# CITY OF ALBUQUERQUE

**Re: New Office Warehouse Facility**  
7000 Huseman Place SW Albuquerque NM  
**Request for Certificate of Occupancy**  
**Transportation Development Final Inspection**  
Engineer's/Architect's Stamp **10-22-18** (M10D016J)  
Certification dated 3-11-20

### TRAFFIC CERTIFICATION

TRAFFIC CIRCULATION LAYOUT PLAN

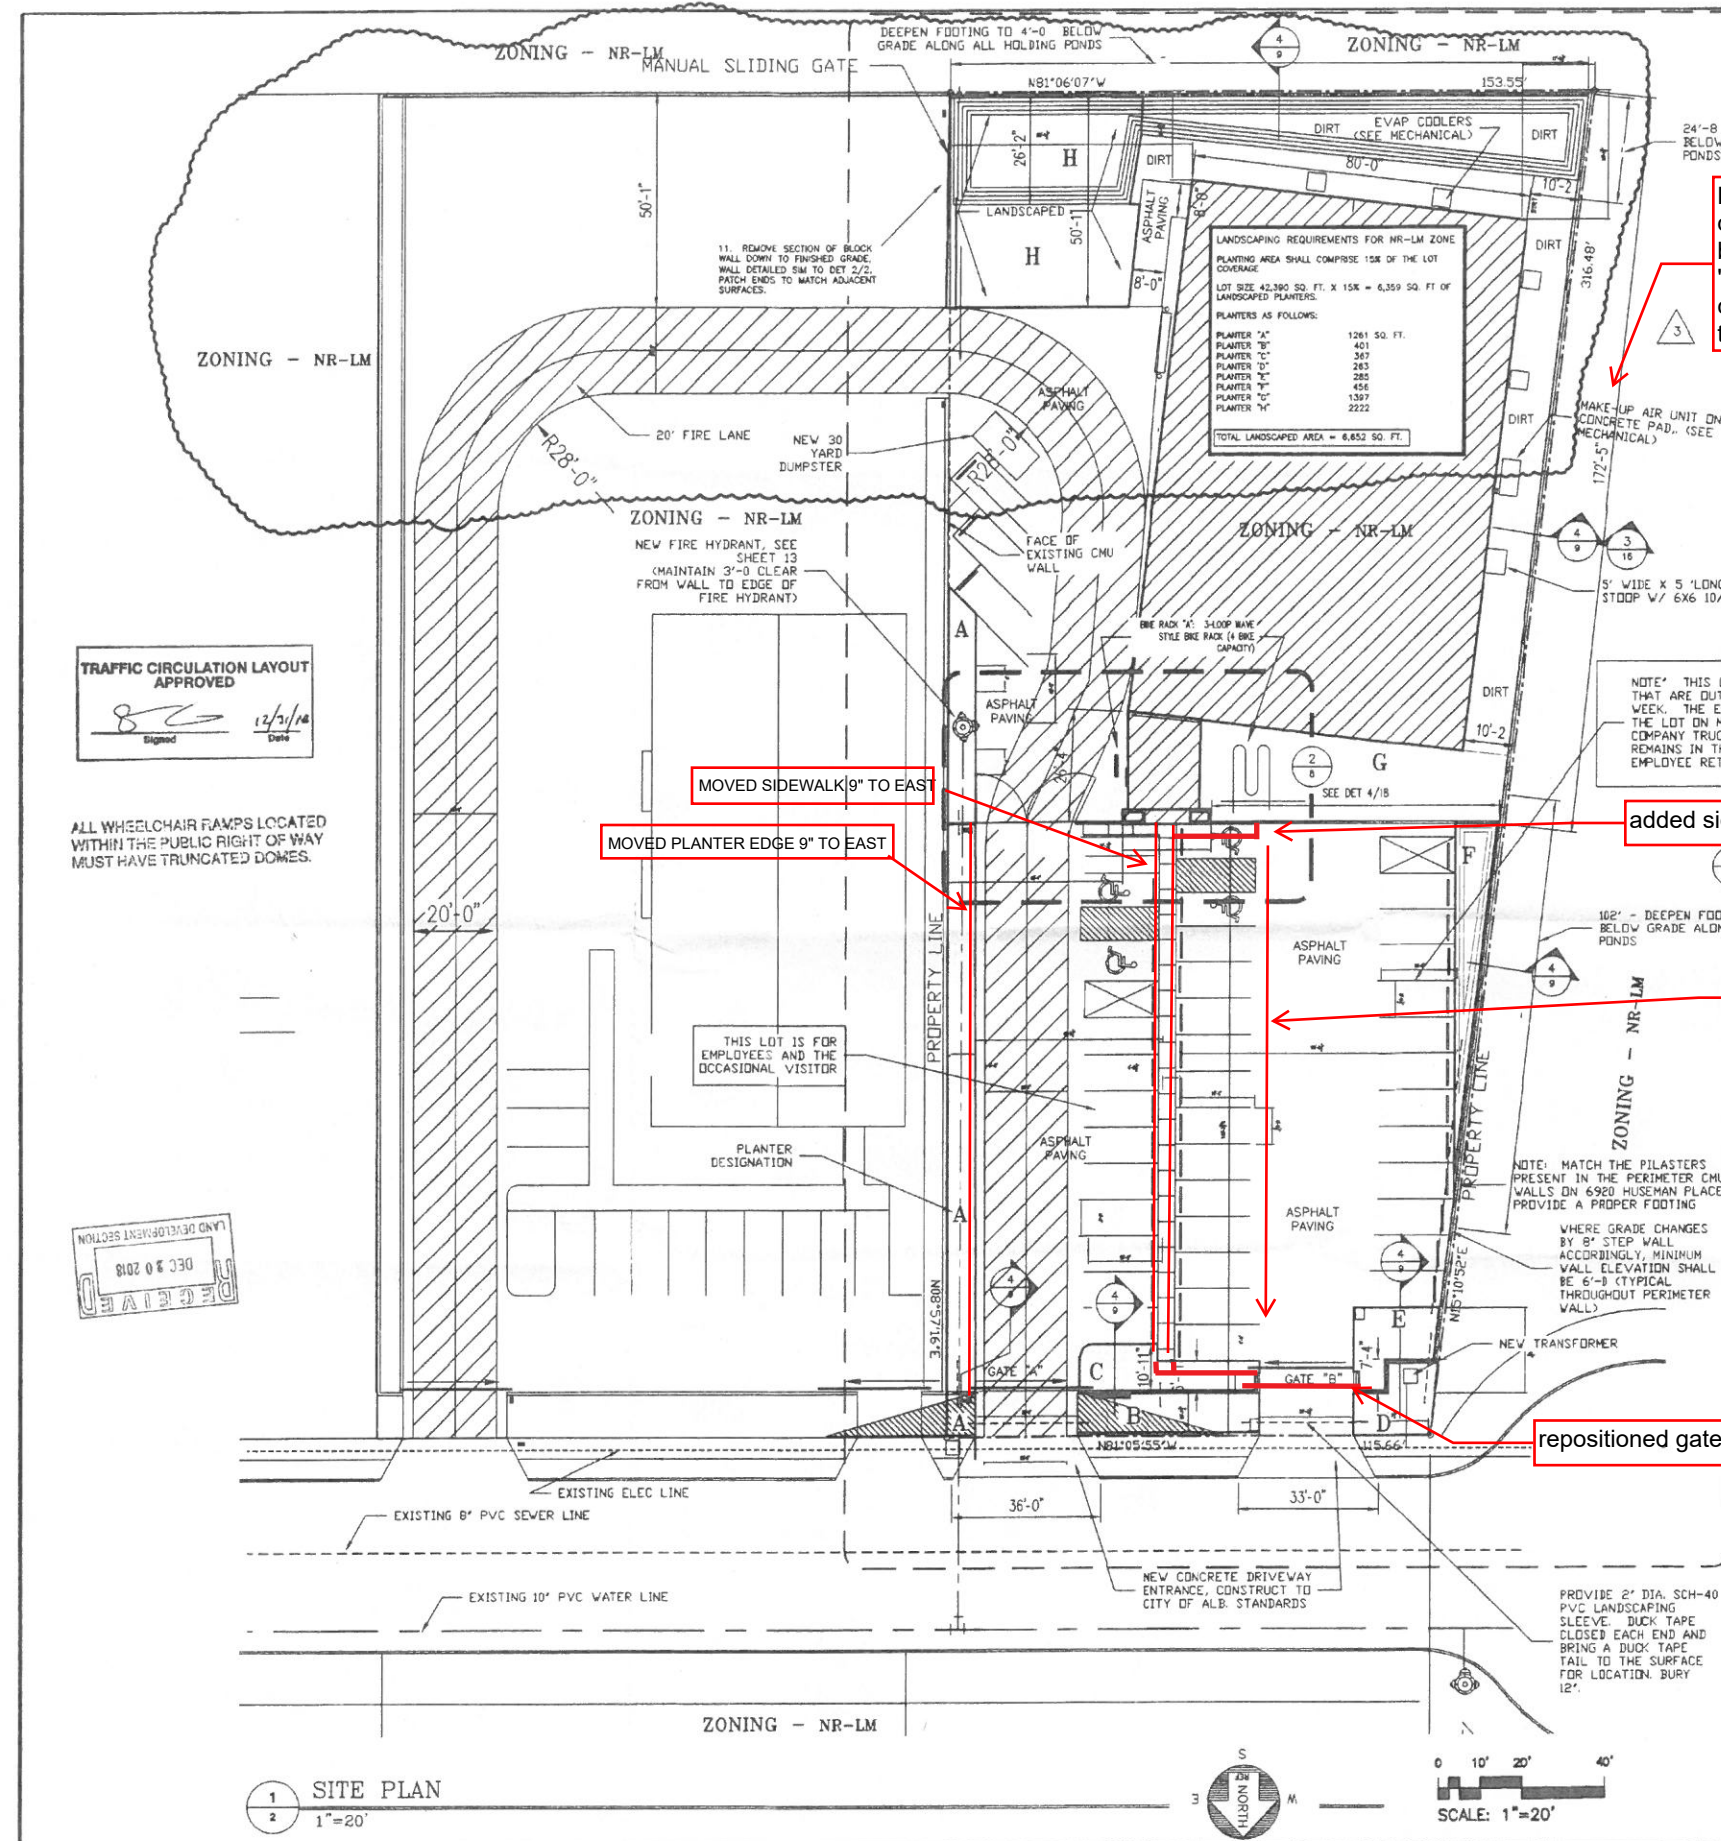
NOTE : this development has been built in "substantial compliance" with the TCL

repositioned gate

- repositioned all parking spaces

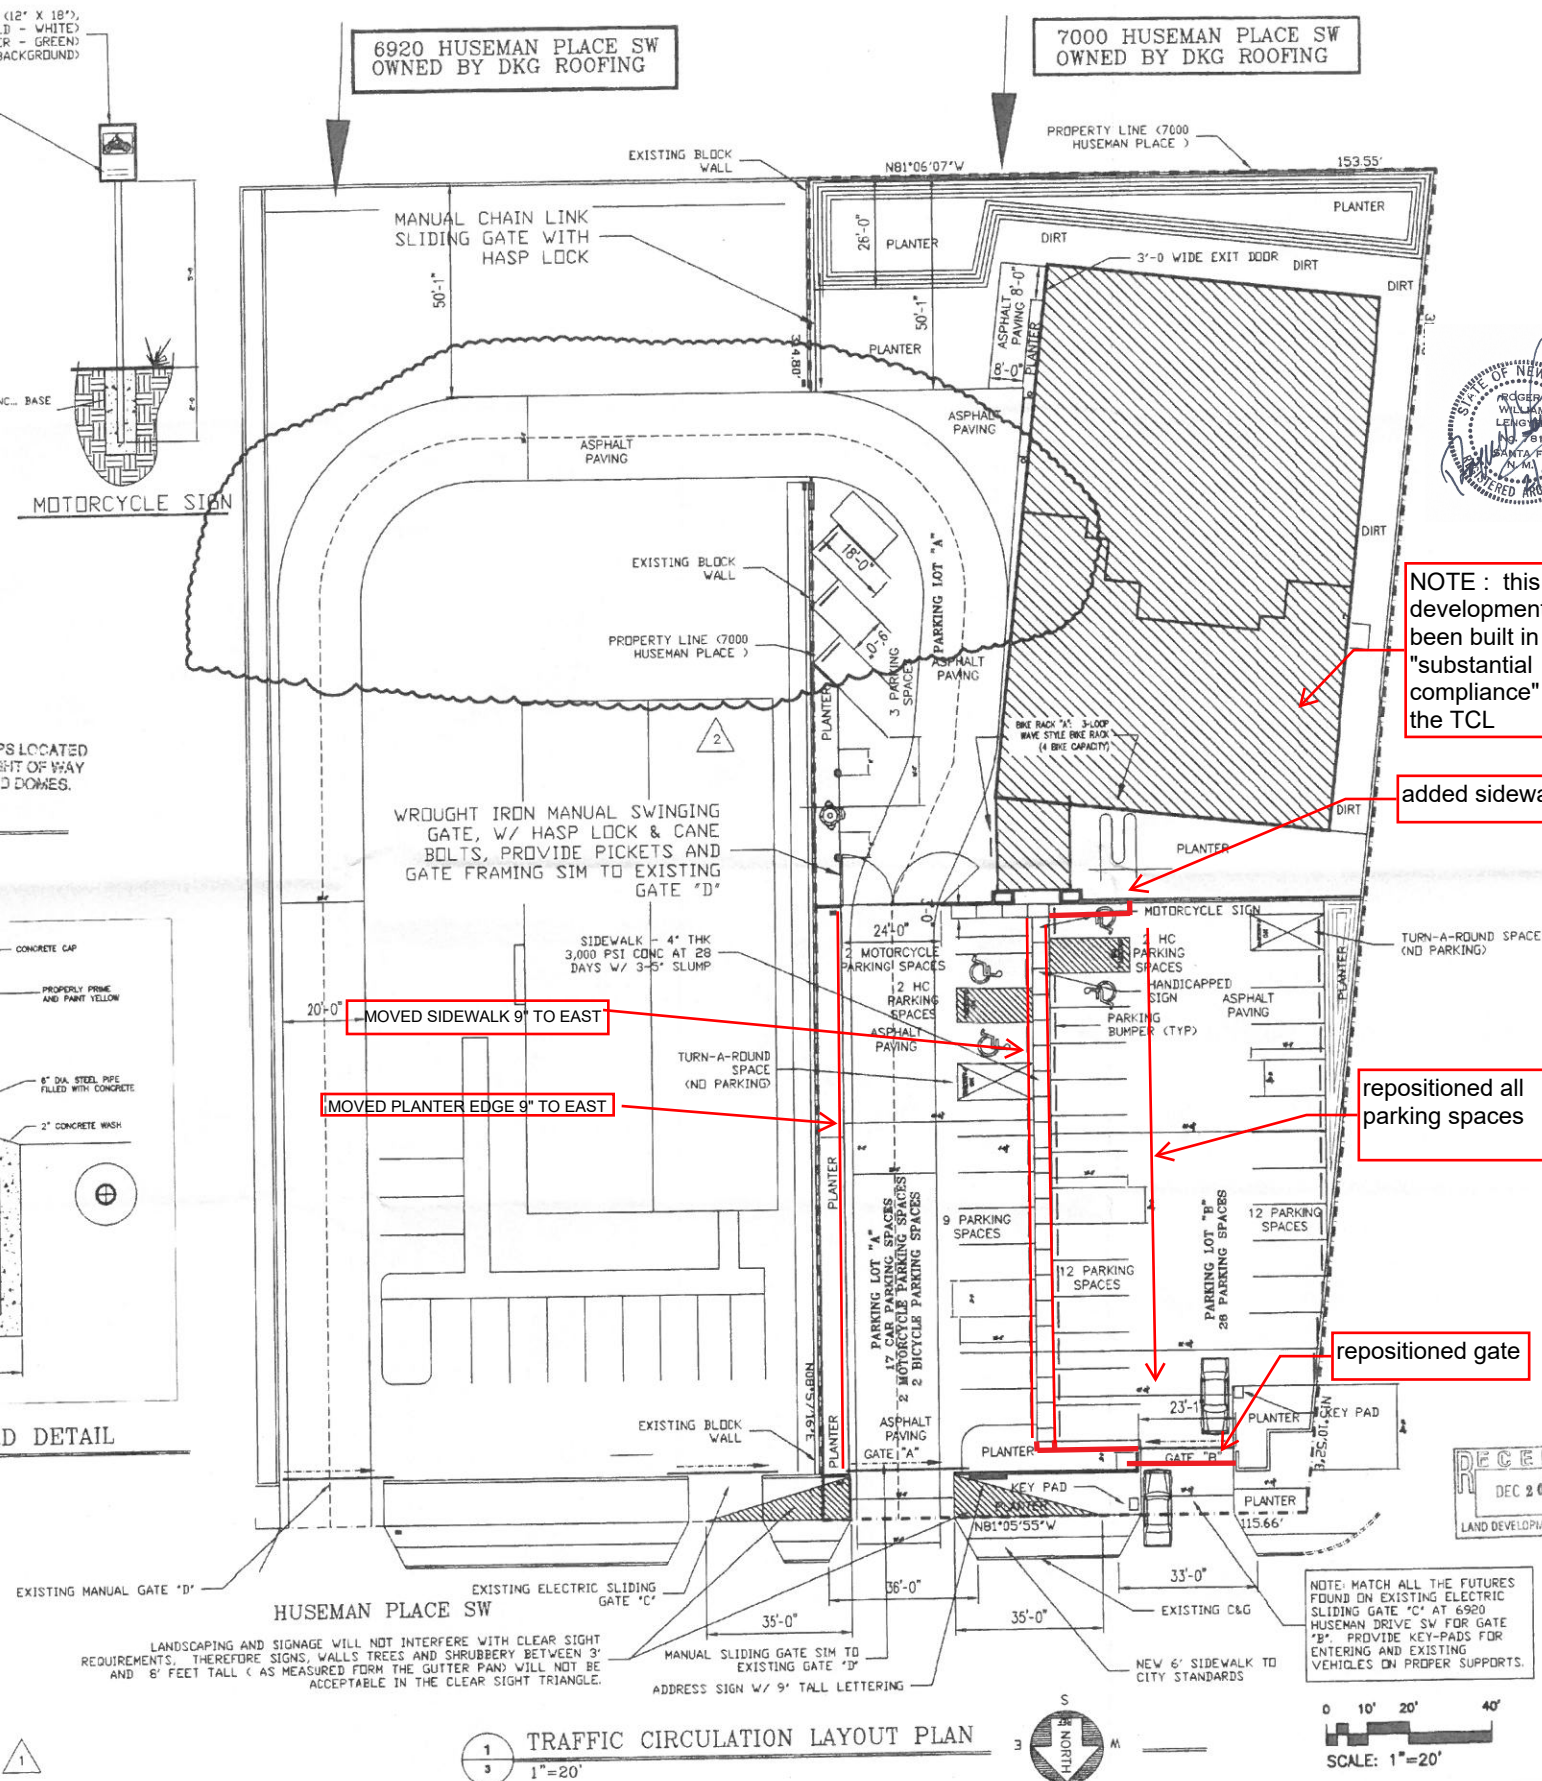
NOTE : this development has been built in "substantial compliance" with the TCL

added sidewalk

- repositioned all parking spaces

repositioned gate
